# Report on Bakhvi 1 HPP Scoping Assessment Document

In the territory of Chokhatauri and Ozurgeti municipalities, on the river Bakhvistskali, in the recreation zone of the resort Bakhmaro, the company "CCH Hydro VI" plans to build and operate a 12 MW diversion HPP. It is noteworthy that the Ministry requested the company to submit additional documentation and clarify a number of issues, including 12 environmental issues, which are also addressed in this assessment document. The additional documentation requested by the Ministry for the company demonstrates the imperfection of the completed scoping report. The abundance of comments presented is a direct indicator of the quality of the scoping document and absolutely logically leaves an objective feeling that the company did not take the procedure seriously and they simply have no answers on the number of issues, including on the feasibility of losses caused by the impact of the HPP in contrast with the anticipated gain.

View of the site selected for the HPP head building from the "Sunset Hill"

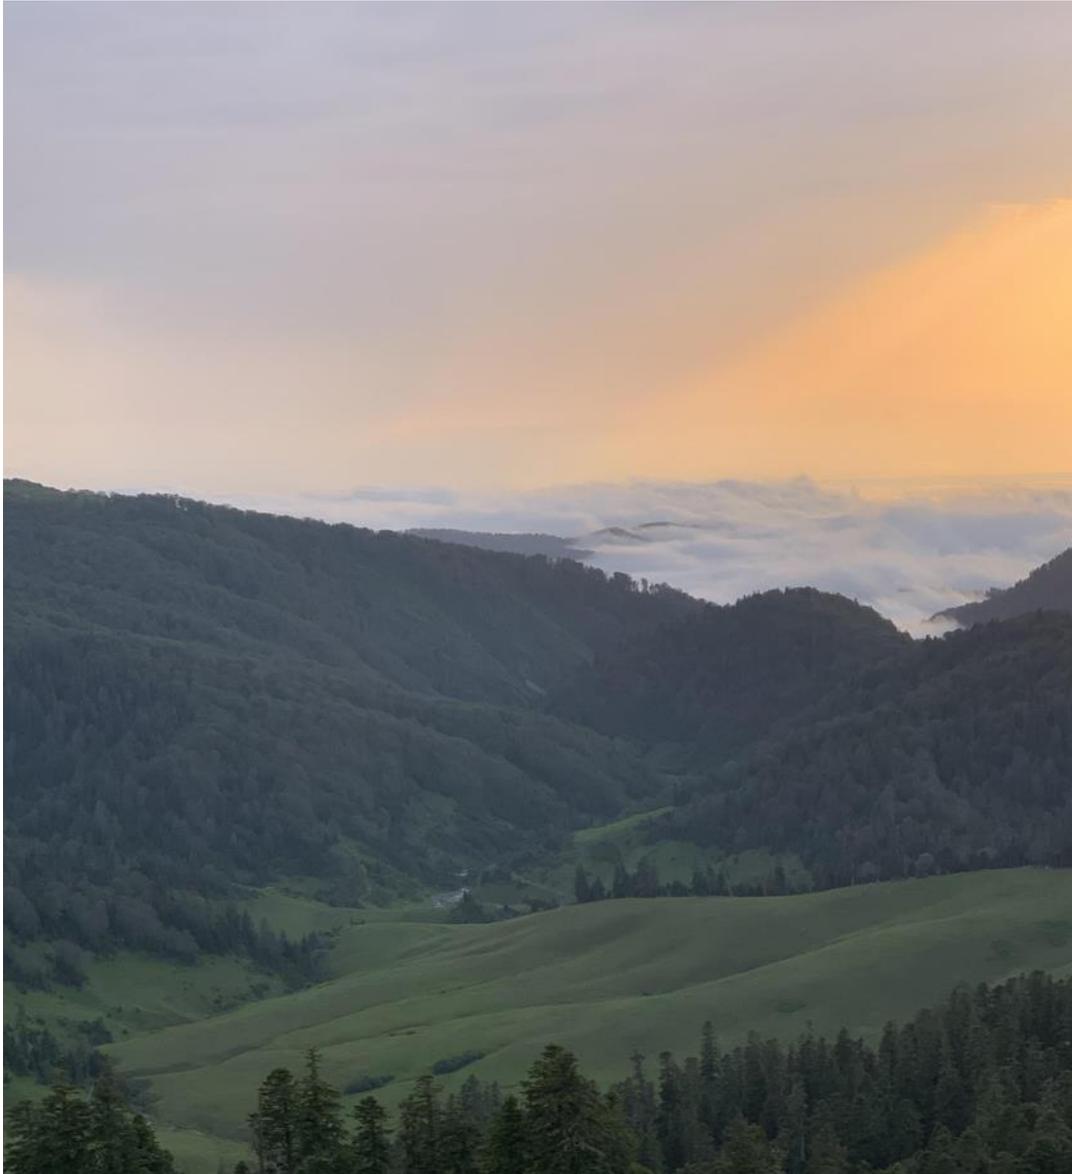
popularity among vacationers. Accordingly, the issue of visual impact on the landscape should be assessed not in terms of the settlement in the lowlands, but in terms of points such as “Fafara Mountain”, so-called “Spring of Beauty” and “Sunset Hill”, famous for beautiful panoramic views of the sunset.

The submission of irrelevant documentation to the submitted simple note suggests that the company is deliberately trying to mislead decision-makers that the hydropower plant will not have a visual impact on the landscape. **During our field trip on June 20, 2021, which aimed to visit the project area of the Bakhvi 1 HPP in the Bakhvitskali River gorge, it was revealed that the HPP headwaters and floodplains are visible from one of the most famous locations of the Bakhmaro resort, "Sunset Hill" which is one of the main gathering places for tourists, because of the scenic panoramic views.** Consequently, the claim that the HPP will not have a negative landscape-visual impact on the resort of Bakhmaro is false.
